DESIGN REVIEW COMMITTEE MEETING AGENDA
Thursday, January 10, 2019, 4:00 PM
City Hall, 616 NE 4th Avenue

11TH AVENUE DUPLEX

FILES: CUP18-01 AND DR18-09

PROPOSAL: To request conditional use approval to construct a duplex residential structure on a single family lot

A2.00

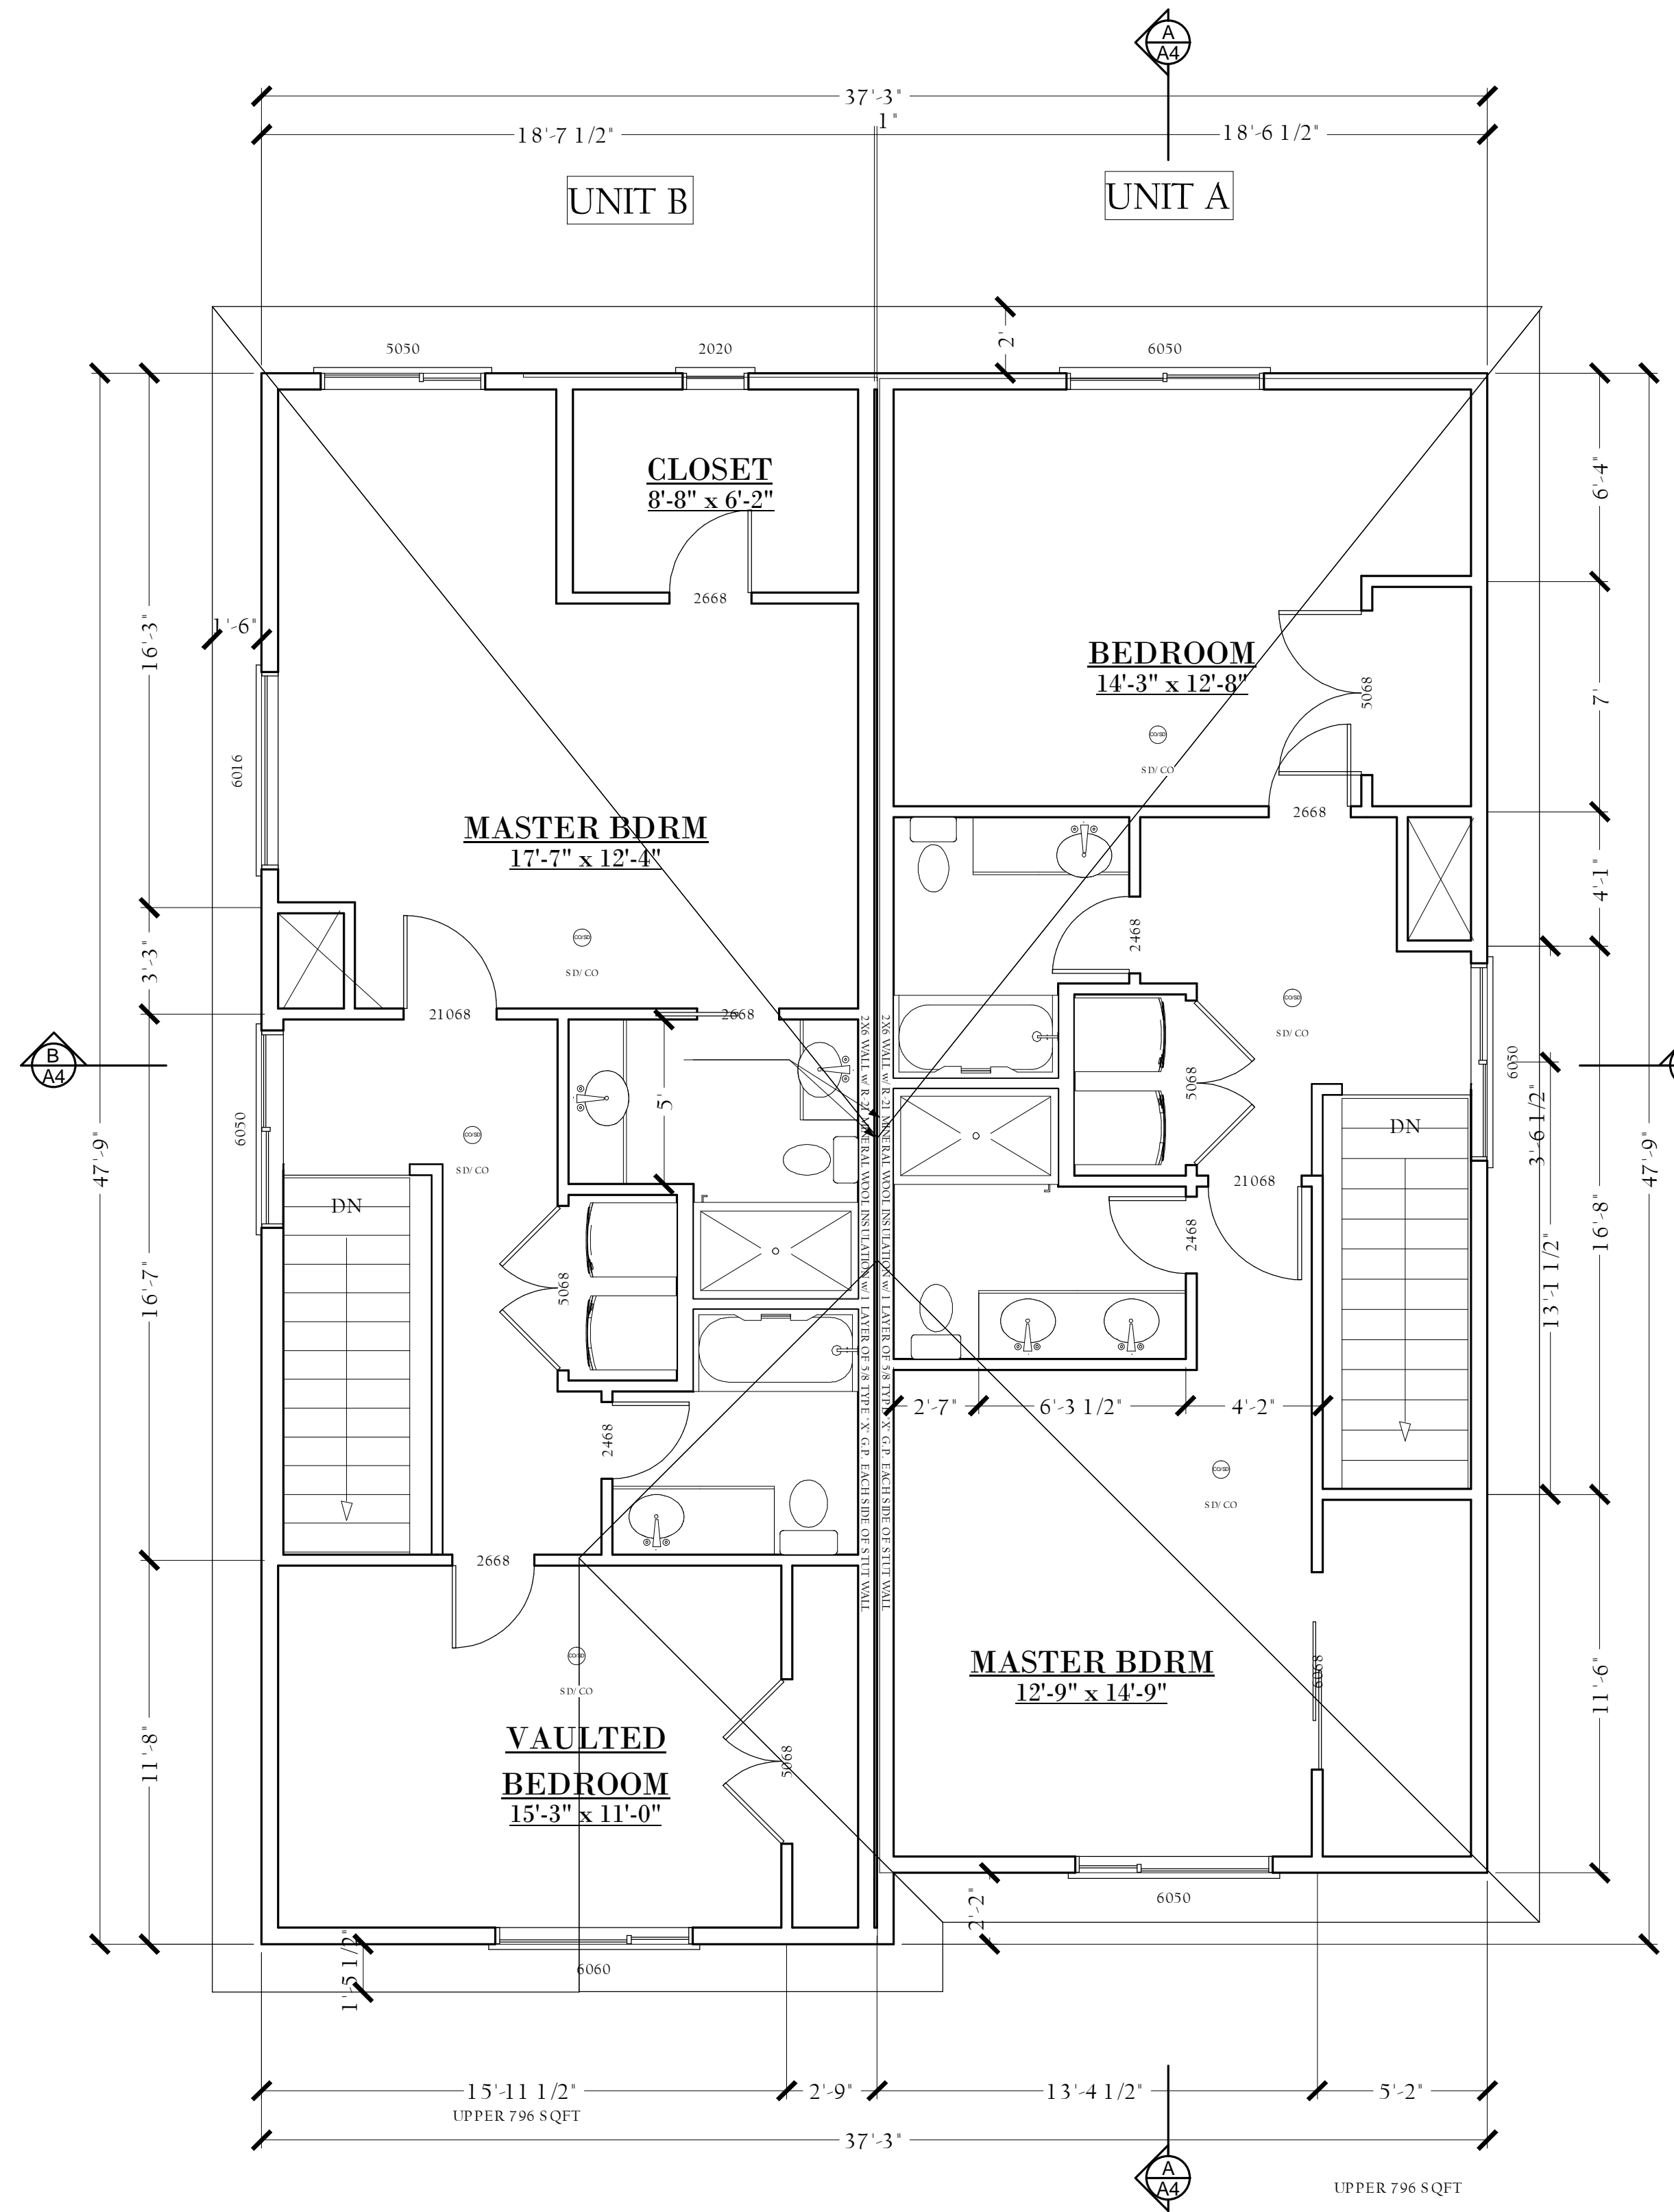
The applicant has proposed a design for the duplex that staggers the units rather than being flush with one another and the front doors are visible from the street. The front doors are set forward of the garage doors for both units as demonstrated on Sheet A2.00. Design Review criteria is discussed in the following section.
